**CERTIFICATE OF APPROPRIATENESS**

**RE: Application Number 20-6757; 867 Edison Street, Boston-Edison Historic District**

16x20 Garage Proposal

LP® SmartSide® 1/2" x 12" x 16' Prefinished Engineered Wood Bold Triple 4" Dutch Lap Siding

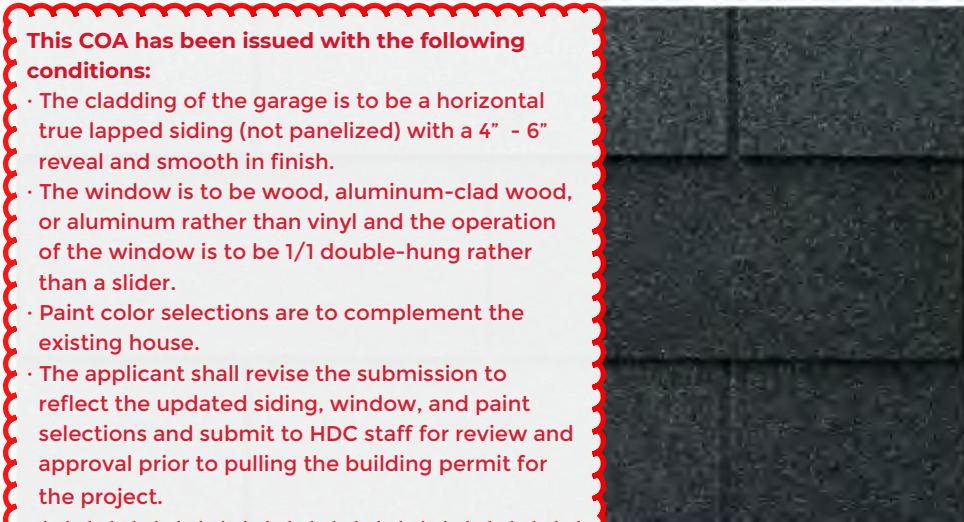
- The cladding of the garage is to be a horizontal true lapped siding (not panelized) with a 4" - 6" reveal and smooth in finish.
- The window is to be wood, aluminum-clad wood, or aluminum rather than vinyl and the operation of the window is to be 1/1 double-hung rather than a slider.
- Paint color selections are to complement the existing house.
- The applicant shall revise the submission to reflect the updated siding, window, and paint selections and submit to HDC staff for review and approval prior to pulling the building permit for the project.
